RESOLUTION NO. 2015-065

A RESOLUTION APPROVING PRELIMINARY AND FINAL DEVELOPMENT PLANS FOR THE AUTO OWNERS INSURANCE BUILDING WITHIN THE EAGLE POINT BUSINESS PARK

City of Lake Elmo Planning Department **Preliminary & Final PUD Plan/Plat**

To: Ben Gozola, Senior Planner, Sambatek Re: Auto Owners Insurance Building

Grading, Drainage, and **Erosion Control** Plan

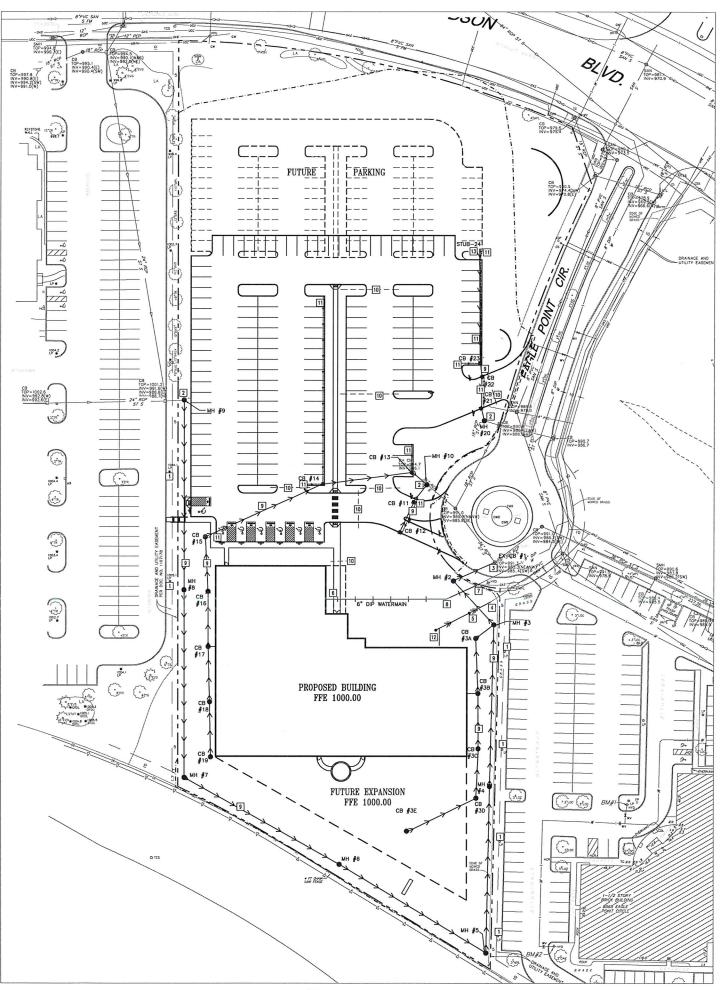
- 1. City Standard Plan Notes for Grading and Erosion Control must be included on the Grading & Erosion Control Plans.
- 2. Minor grading revisions are needed to maintain maximum slopes of 4:1 within public R/W (Hudson Boulevard).

Utility Plan

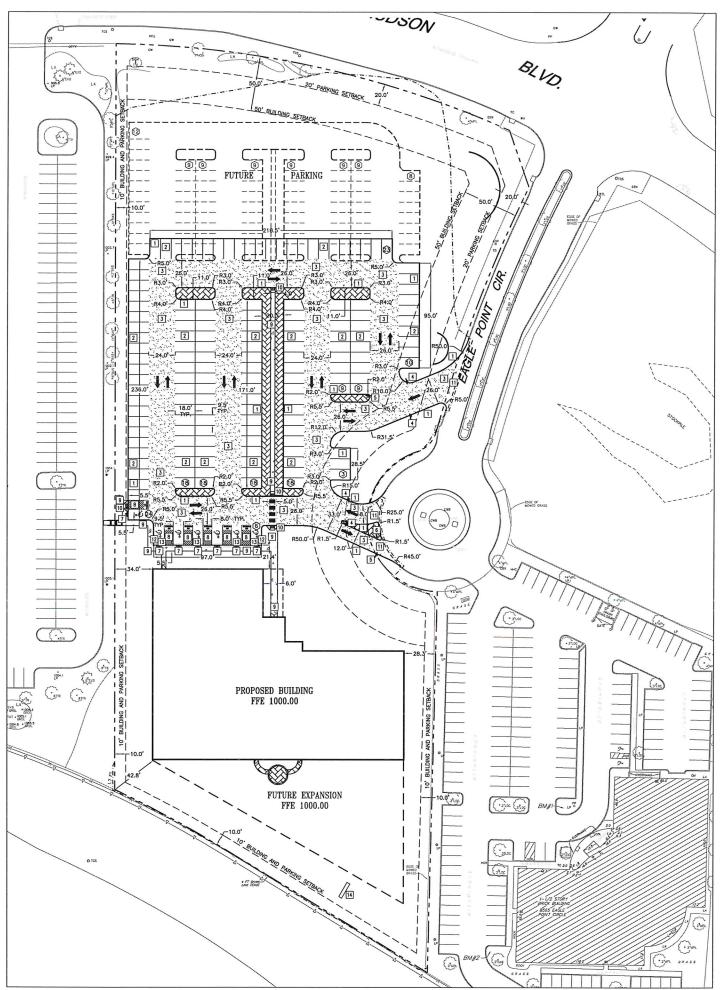
- 1. Connection to existing sanitary sewer stub. The project proposes to connect to the existing sanitary sewer stub located in Eagle Point Circle.
- 2. Connection to existing watermain stub. The project proposes to connect to an existing 8-inch watermain located in Eagle Point Circle and extend a 6-inch watermain service to the building.
- 3. Fire Hydrant locations. No fire hydrants are proposed in the project, however one fire hydrant exists within 65 feet of the proposed building. The hydrant system plan must be reviewed by the Fire Chief. Comments will be forwarded if plan changes are deemed necessary.

Stormwater Pollution Prevention Plan

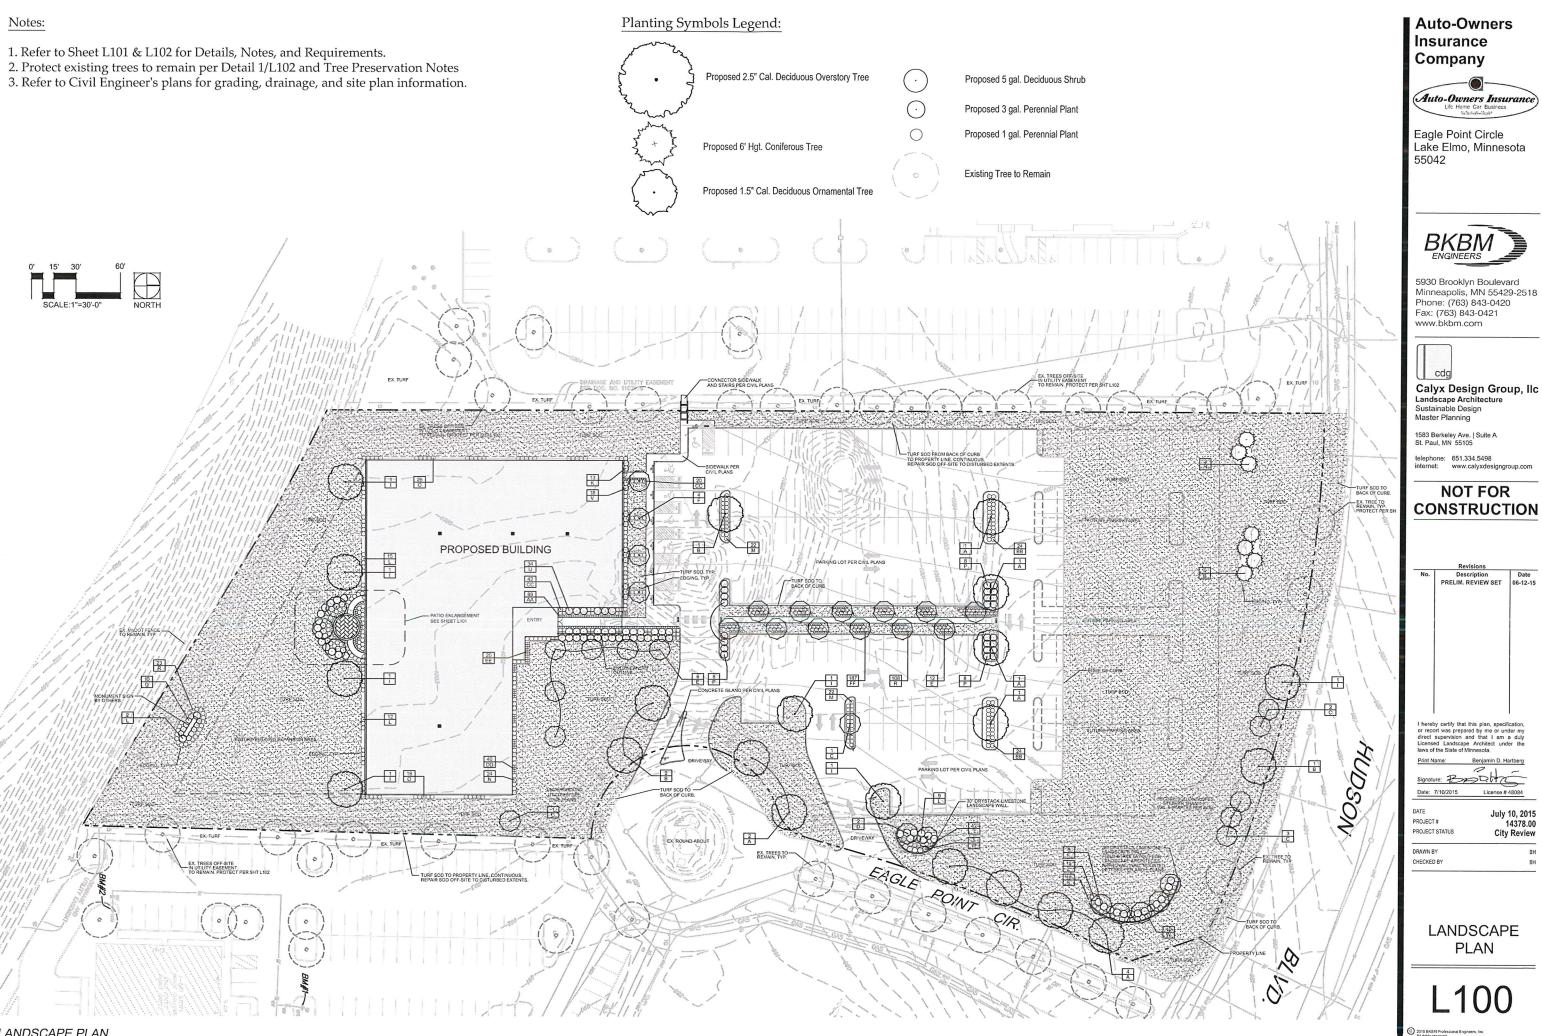
- 4. SWWD Permit. The Storm Water Management Plan has been reviewed and approved by the SWWD. The review determined that the existing regional basin constructed in year 2000 for the business park development provides the necessary capacity for storm water rate and water quality requirements to meet SWWD rules.

- 5. MPCA Stormwater Construction Permit. The applicant is required to apply for and receive a Stormwater Construction Permit from the MPCA once a contractor has been obtained for the project. MPCA permit requirements include a provision that requires on-site infiltration of 1-inch of rainfall over all new impervious surfaces (17,279 cubic feet). The applicant believes the discharge to the regional pond facility will provide the infiltration needed to meet this requirement.

- 6. MPCA Permit Contingency. The applicant has indicated to the City that if the MPCA review determines that the regional pond facility does not conform to MPCA rules, the applicant will construct underground infiltration systems that will not alter the proposed site plan.
